## RESPONSES TO COMMENTS ON DRAFT VOLUME I, CHAPTER 3A

Paul Julian<sup>1</sup>, Grover G. Payne<sup>2</sup> and Shi Kui Xue

### Level of Panel Review: Accountability

Reviewer: V. Novotny (AA)

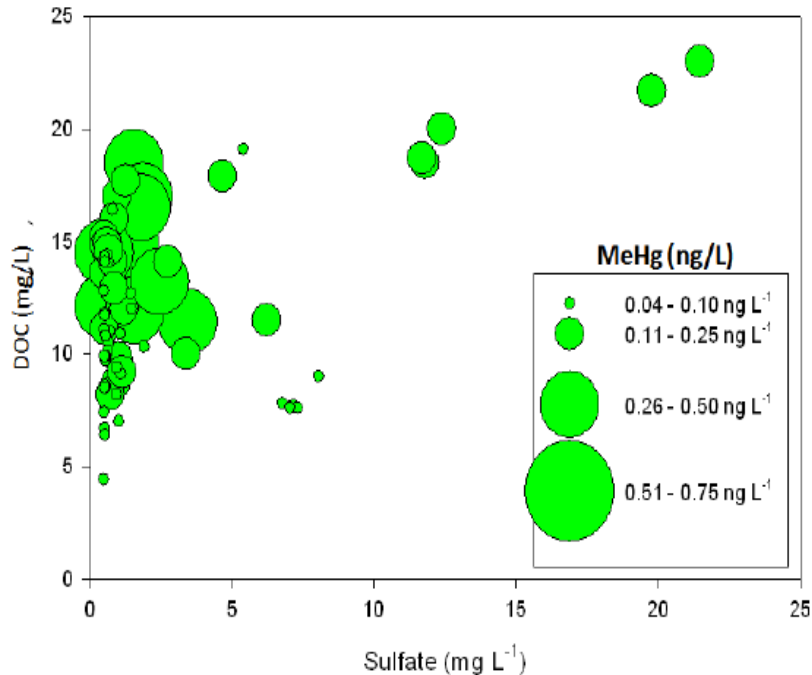
were pointed out on page 3A-17 as being 75% higher than in the preceding water year. This means that more dissolved phosphorus will be released into the pore water of the sediments and, subsequently, potentially in the water above the sediment. However, in the interiors of WCA-2, WC-3 and EPA, 25th percentile to median values were between 1 to 5 mg/L which is the “Goldilocks” window at which methyl-mercury is suspected to be formed. It appears that all three could be adversely affected by the sulfate concentrations in the 1 to 5 mg/L sulfate window (see Figure below).

This figure taken from the 2012 SFER shows the 1-5 mg/L sulfate window in which methyl mercury can be formed at higher concentrations if the dissolved organ carbon (DOC) is between 10 – 20 mg/l , (i.e., the water body is organically enriched by algae development). The methyl mercury formation is only mildly affected by mercury inputs because the atmospheric Hg deposition could be sufficient.

**Response #12:** Noted. Due to the nature of the comments and the substance of Chapter 3B, comments associated with sulfate and mercury methylation will be addressed in the peer review responses for that chapter.
